**RE: Schwartzwalder Mine, Permit No. M-1977-300, 112d-2 Amendment Application (Revision No. AM-6), Notice of Objections Received**

## Comments on Schwartzwalder Mine - File No. M-1977-300, Colorado Legacy Land LLC Amendment Application (AM-6)

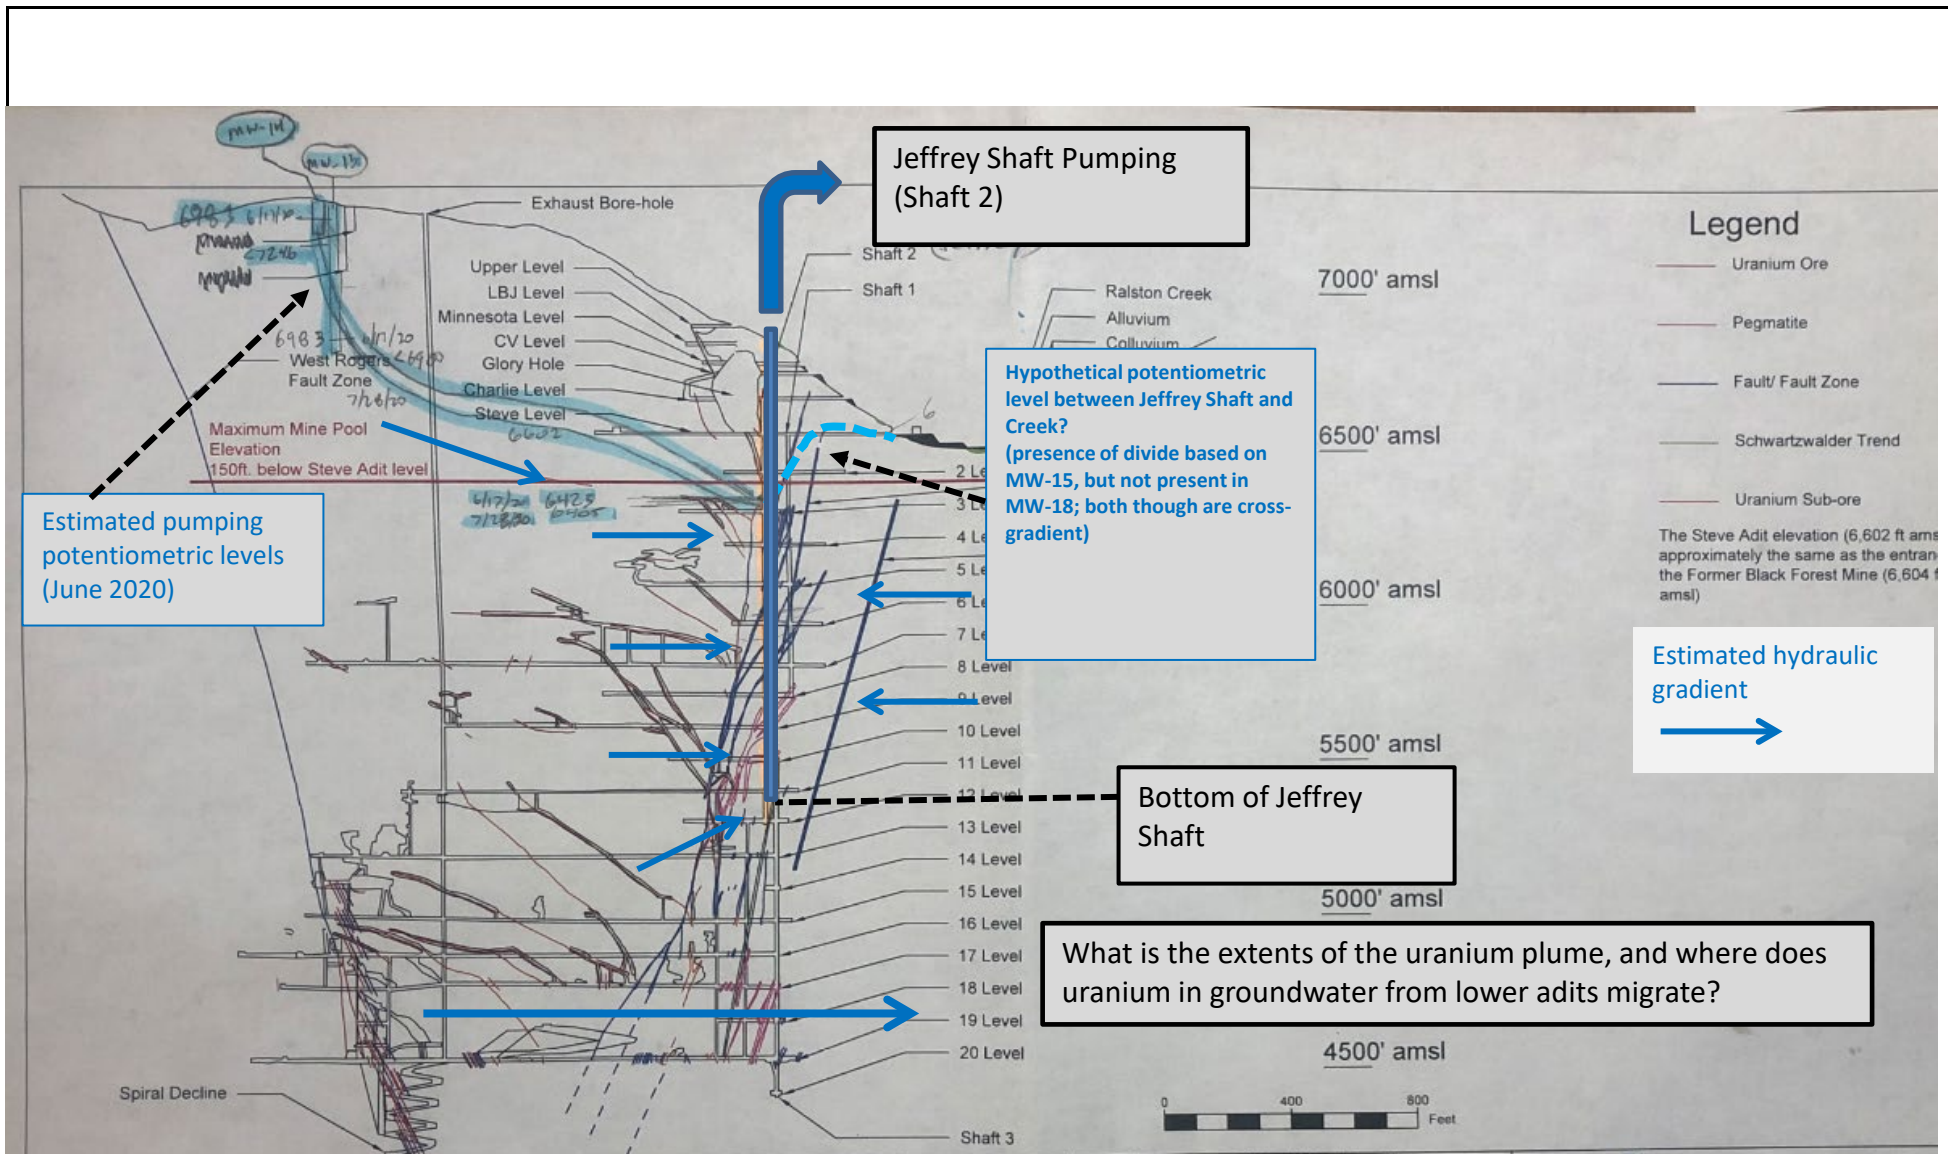
- Provide two figure/diagrams depicting the delineation of potential migration pathways from the mine pool through bedrock groundwater, and other fractures or faults such as the Illinois Fault Zone. An example of a cross-section is shown in **Figure 1**.

Furthermore, as stated in the memo addressing physical and chemical stabilization of the mine pool, data presented are insufficient to assert that an inward bedrock groundwater gradient has been established for all areas of the uranium plume in bedrock groundwater. CLL uses only two bedrock monitoring wells, one of which only has three data points dating to Q2 2020, and both of which are essentially cross-gradient.

In addition, Figure 2 depicts an estimate of the bedrock mine pool pumping capture zone based on the bedrock groundwater elevations. Since CLL has described the pumping capture zone as anisotropic, additional bedrock groundwater elevations and more bedrock groundwater wells (particularly within the permit boundary immediately east/northeast of the mine pool pump and southwest of Ralston Creek) would be necessary to demonstrate an inward groundwater gradient towards the mine pool.

Figure

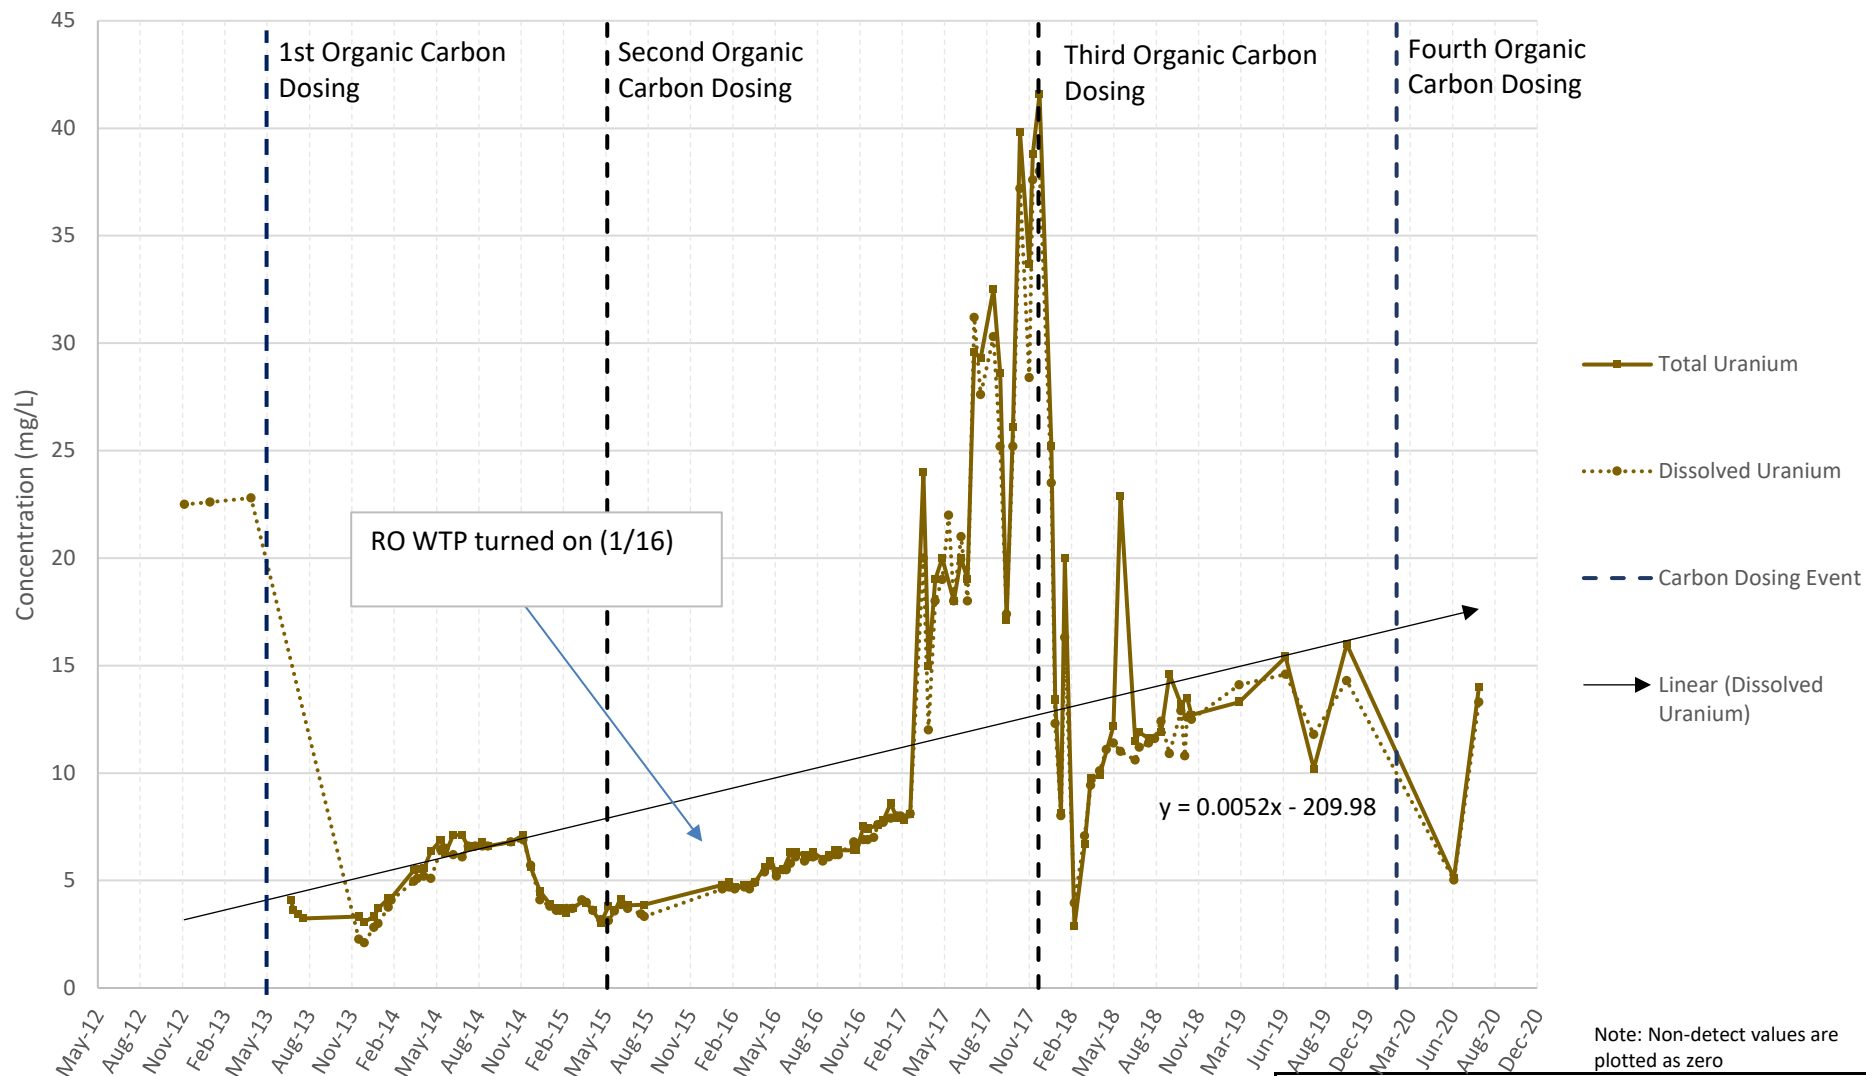
Although there are a limited number of bedrock monitoring wells which can be used to draft potentiometric contours, an estimate of the mine pool pumping capture zone based on the existing bedrock groundwater elevation (potentiometric) data is shown in **Figure 1**. Capture zone estimates are typically drawn in plan view and cross-section to fully illustrate the area in which inward hydraulic gradients exist due to pumping. Although CLL has demonstrated inward gradients based on two wells cross-gradient to the pumping area (MW-15, MW-18), they have not illustrated the capture zone relative to the mine workings or permit boundary. In Section E.5.1 (p. 15) CLL
